# MEETING AGENDA

## Appearance Commission

A. **Public Meeting** for Case 26-17: Appearance Review for Metra TPSS/Substation Facility at 18277 Park Avenue

B. **Public Meeting** for Case 26-34: Appearance Review for 7Brew Drive-Thru Coffee at 17855 Halsted Street

**1 EXTERIOR ELEVATION - WEST**  
 3/8" = 1'-0"

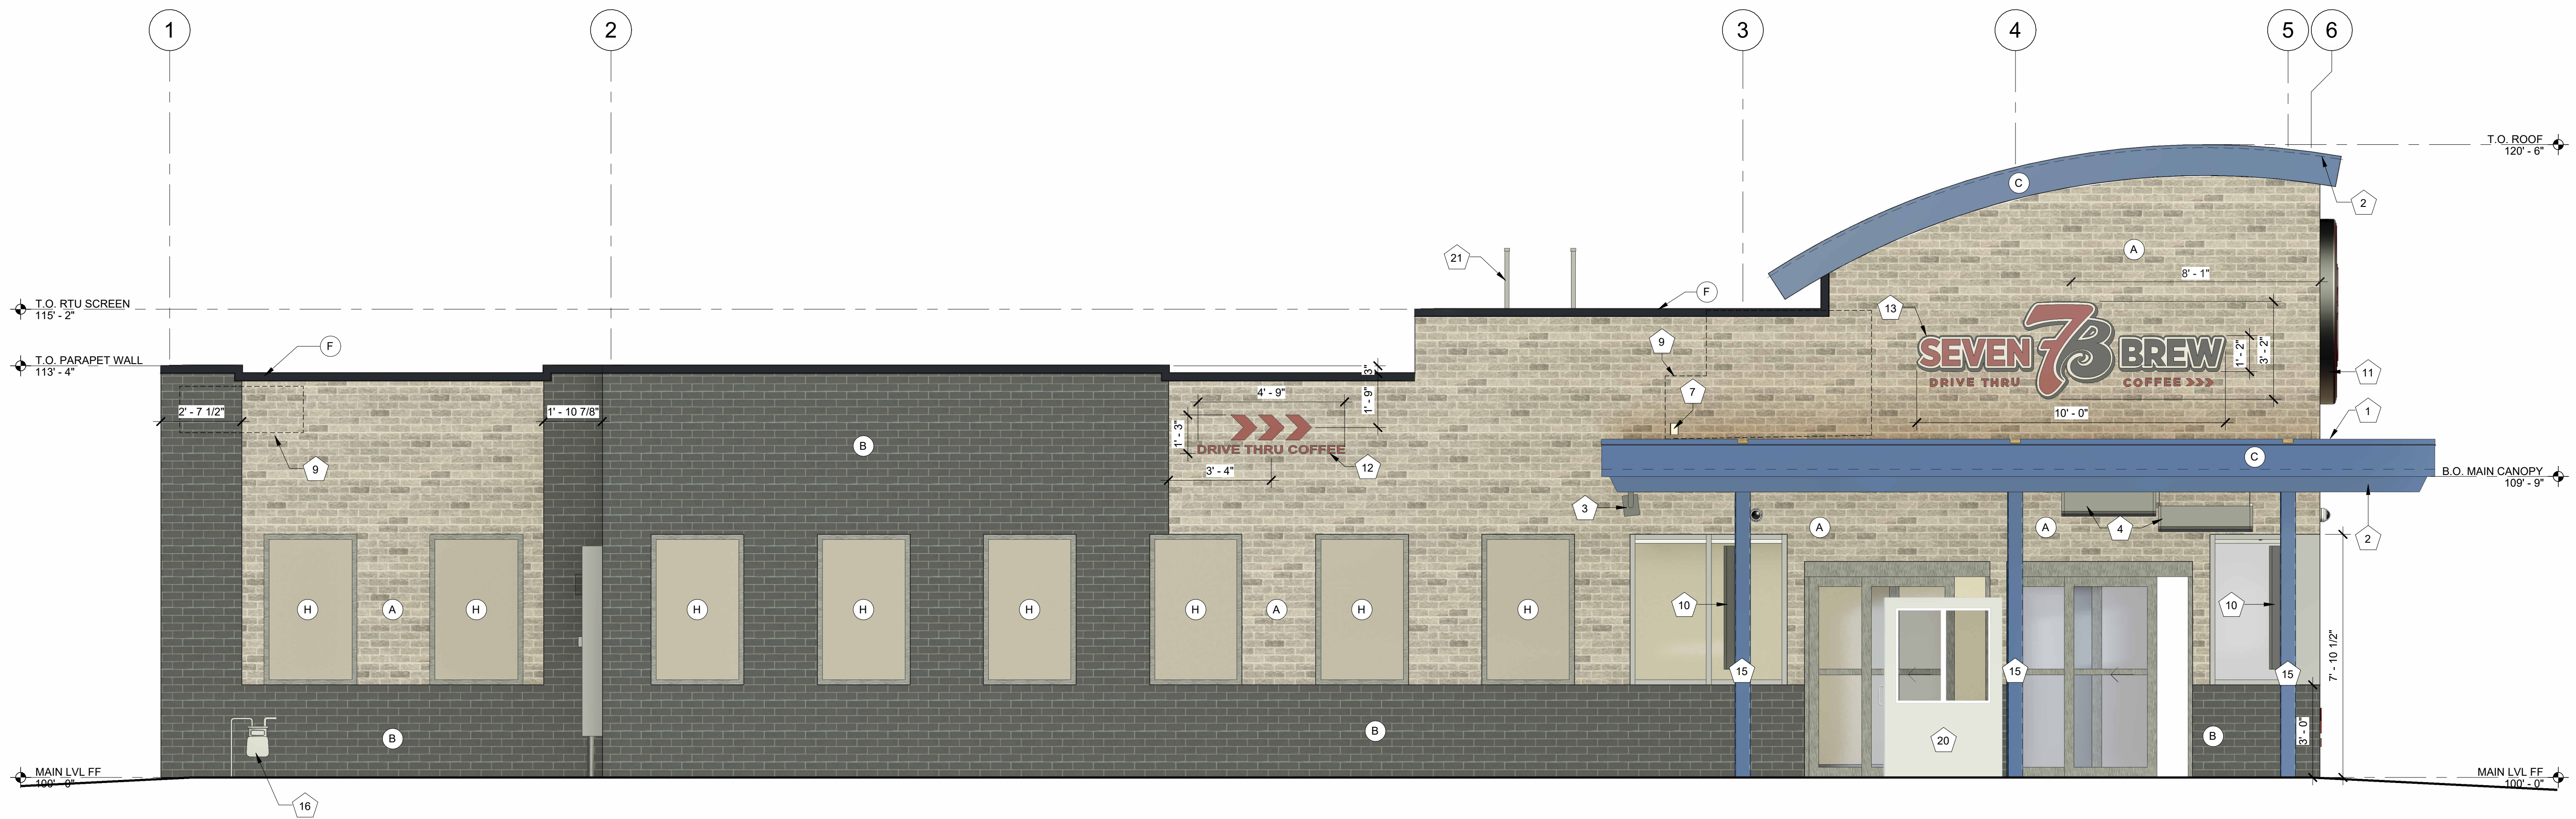
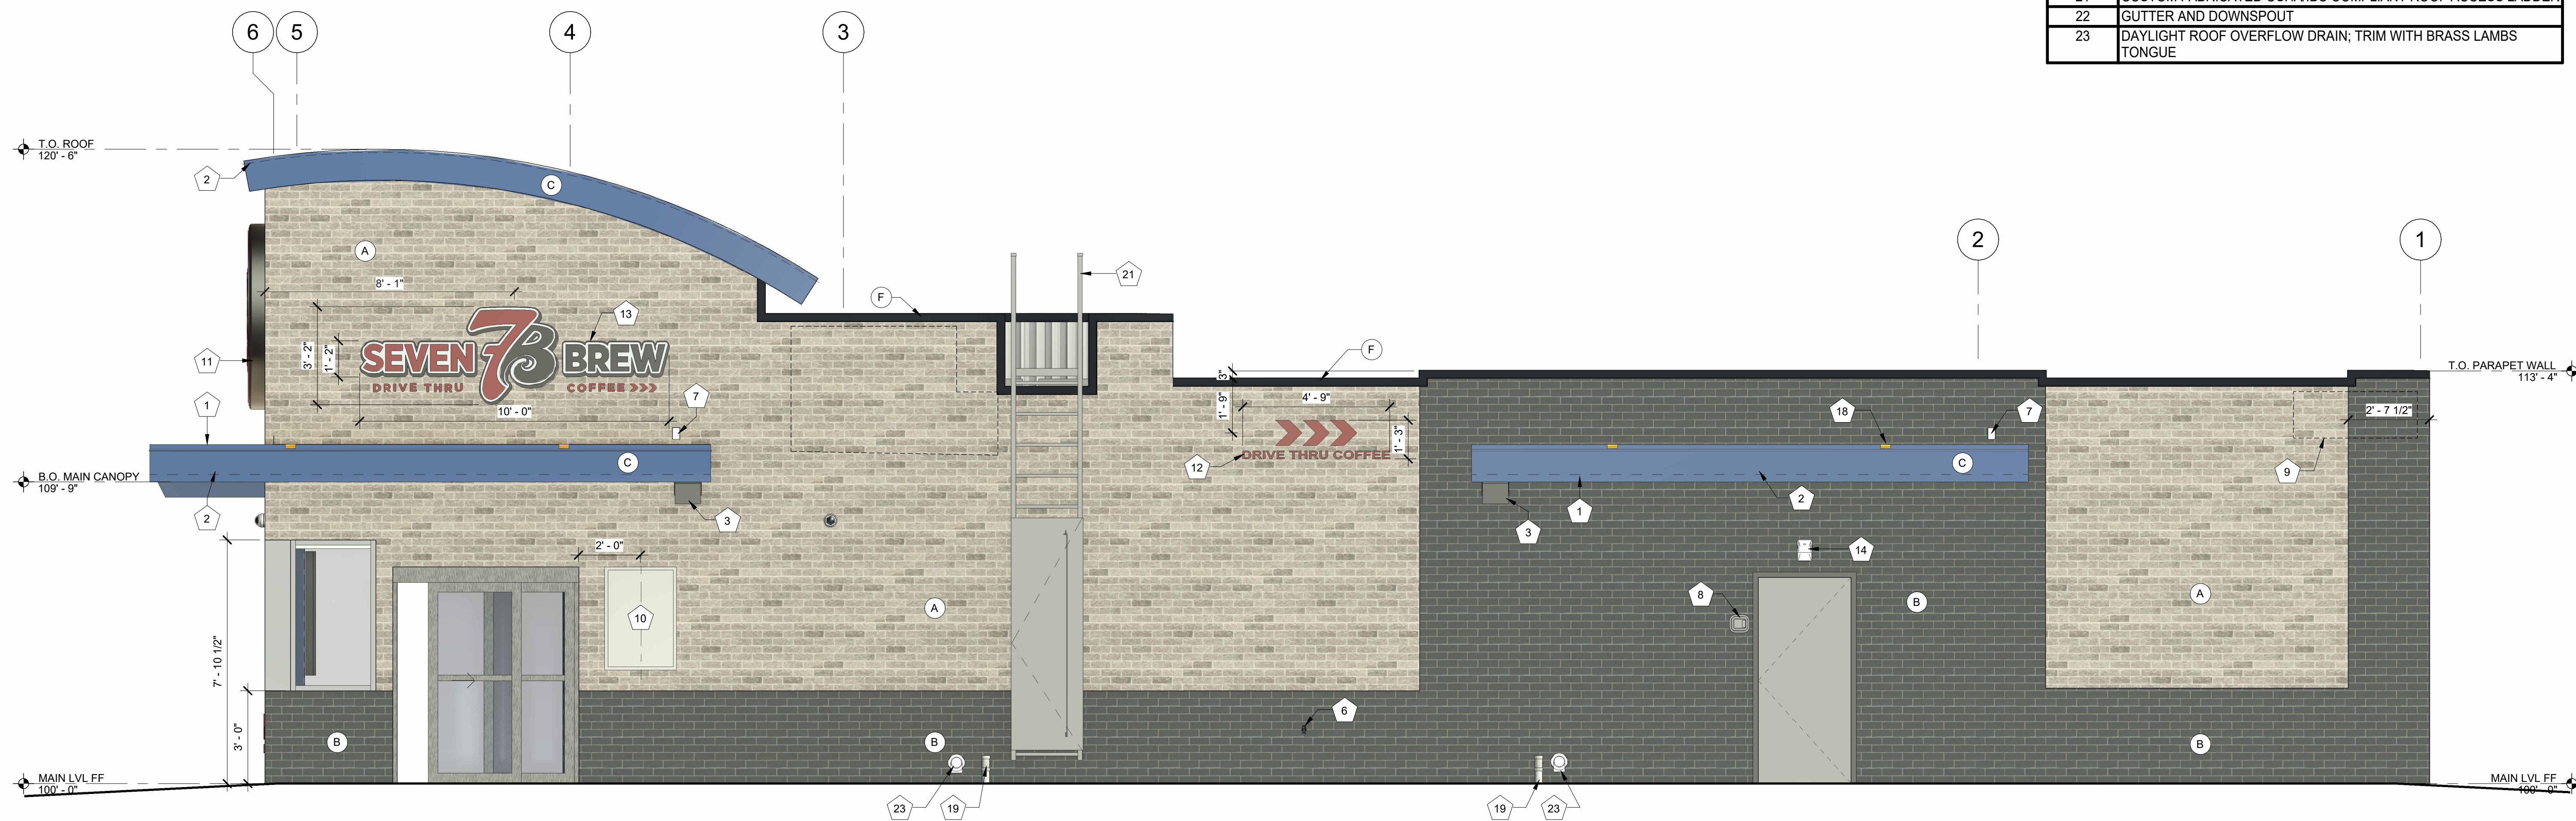
Fiber cement panels are considered as a Tier II material. Tier II materials may not cover more than 50% of the front of the building, or 75% of the other sides of the building. **The applicant shall provide a revised set of elevations which meets the design requirements of the Village zoning ordinance or request a variance from the building material requirements through the zoning variance procedure.**

1. Submit a revised landscape plan to provide shrubs/grasses and understory/evergreen trees as required by the Village Zoning Ordinance and the Halsted Street Corridor Landscape Plan, subject to review by Village planning staff and Village Arborist;
2. Director of economic and community development shall provide a waiver of the transparency requirements for the building as permitted in Section 44-05-11.(d) of the Village Zoning Ordinance;
3. Applicant shall receive a variance from Tier I material standards set forth in Section 44-05-11 of the Village Zoning Ordinance.
